**FREDERICK COUNTY PLANNING COMMISSION**  
**May 8, 2013**

**TITLE:** **Westview South Lot 110**

**FILE NUMBER:** **SP 98-36, AP #13360, APFO #13348, FRO #13349**

**REQUEST:** **Site Plan Approval**

Graphic #1

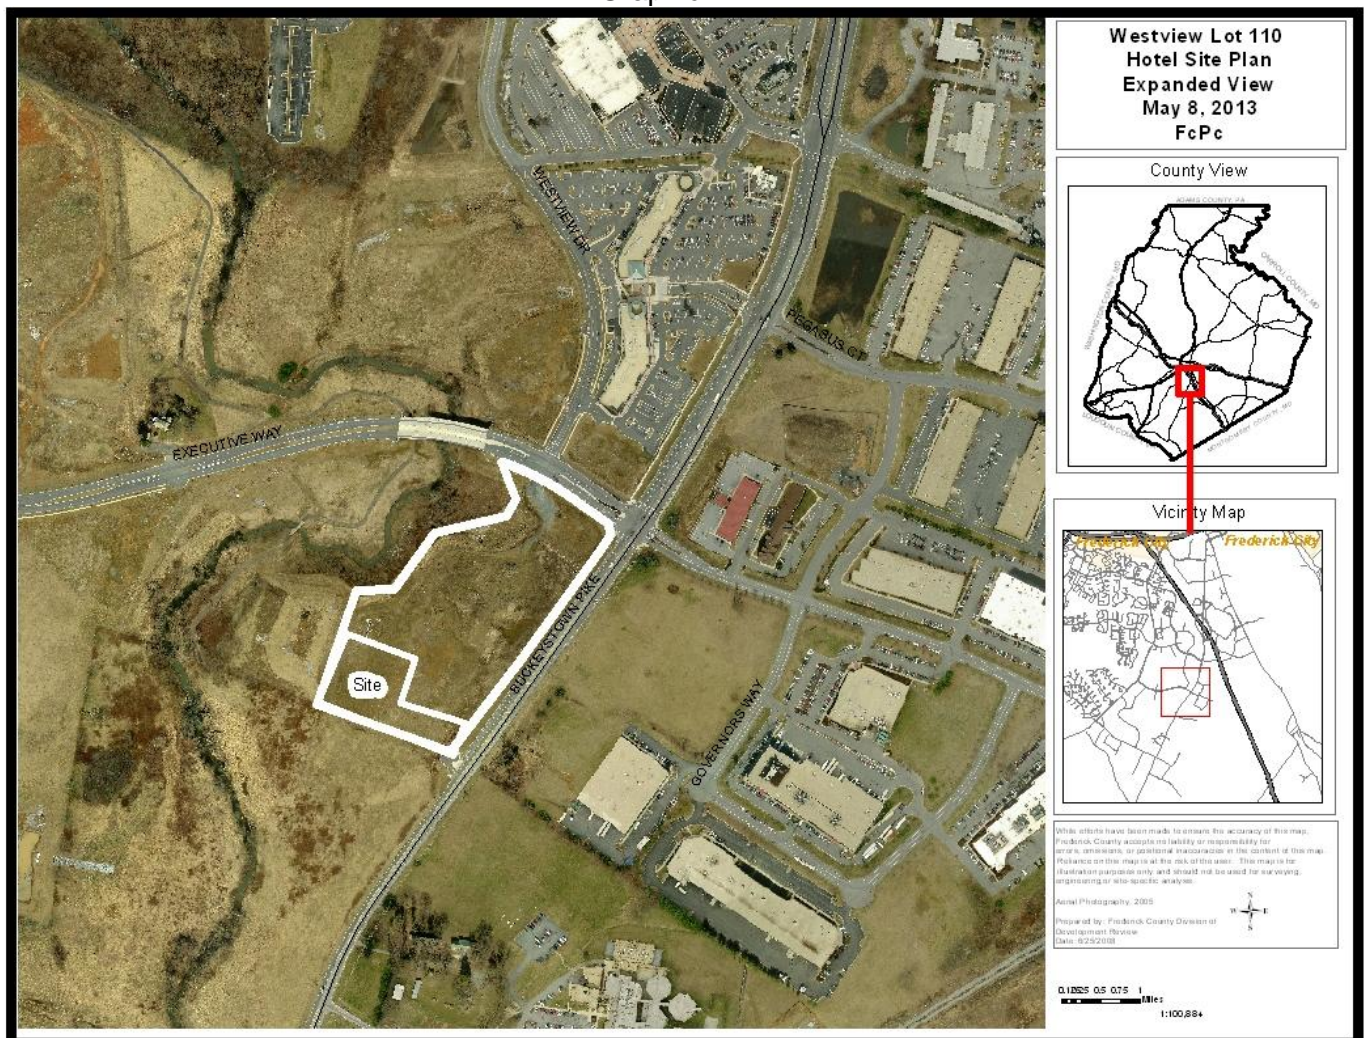
The Applicant is requesting Site Plan approval for a 117 room hotel, on a 3.50-acre site known as Lot 110 within the Westview South 100 Series Lots; see Exhibit #1, located on the corner of MD 85 and Executive Way. See Graphic #1 below.
